Access Compliance Report

(Curb Ramps)

Intersection ID: N/A	Main Street: STEEL_CREEK_RD	Cross Street: SHOPTON_RD	Location: E
ADA ID: A7405E072368	Ramp Type: Perp	Initial Pass/Fail: Fail	Overall Compliance: No
		Severity Score: 12.5	
Codes/Mitigation Info/Possible Solution		Field Measurements/Component Compliance

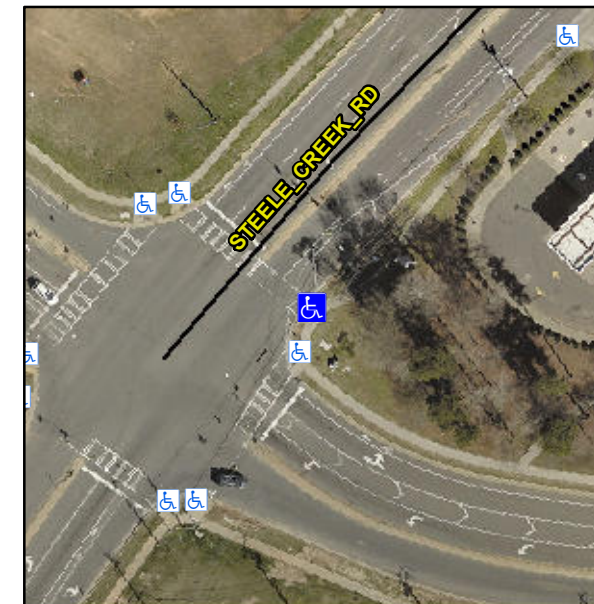
Not Found, R304.2.2

Compliance	Description	Data	Compliance	Description	Data
N/A	Ramp Length (in)	54.0	No	Ramp Slope (%)	8.6
Yes	Ramp Width (in)	49.0	Yes	Ramp XSlope (%)	0.3
N/A	Flare Type LT	N/A	N/A	Flare Type RT	N/A
N/A	Flare Slope LT (%)	N/A	N/A	Flare Slope RT (%)	N/A
N/A	Flare Traversable LT?	N/A	N/A	Flare Traversable RT?	N/A
N/A	Landing Length (in)	N/A	N/A	DWS Provided?	N/A
N/A	Landing Width (in)	N/A	N/A	DWS Contrast?	N/A
N/A	Landing Slope (%)	N/A	N/A	DWS Length (in)	N/A
N/A	Landing X Slope (%)	N/A	N/A	DWS Full Width?	N/A
N/A	Landing Curb? (Y/N)	N/A	N/A	DWS Offset (in)	N/A
N/A	Shared Landing?	N/A			
N/A	Gutter Ponding?	N/A	N/A	Gutter Slope (%)	N/A
N/A	Gutter Lip Ht (in)	N/A	N/A	Gutter X Slope (%)	N/A
N/A	Painted X Walk1?	Yes	N/A	Painted X Walk2?	N/A
	X Walk 1 Direction	To NW		X Walk 2 Direction	N/A
N/A	X Walk 1 Width (in)	114.0	N/A	X Walk 2 Width (in)	N/A
	X Walk 1 Slope (%)	4.8		X Walk 2 Slope (%)	N/A
	X Walk 1 X Slope (%)	1.0		X Walk 2 X Slope (%)	N/A

Remove & Replace Entire Ramp.
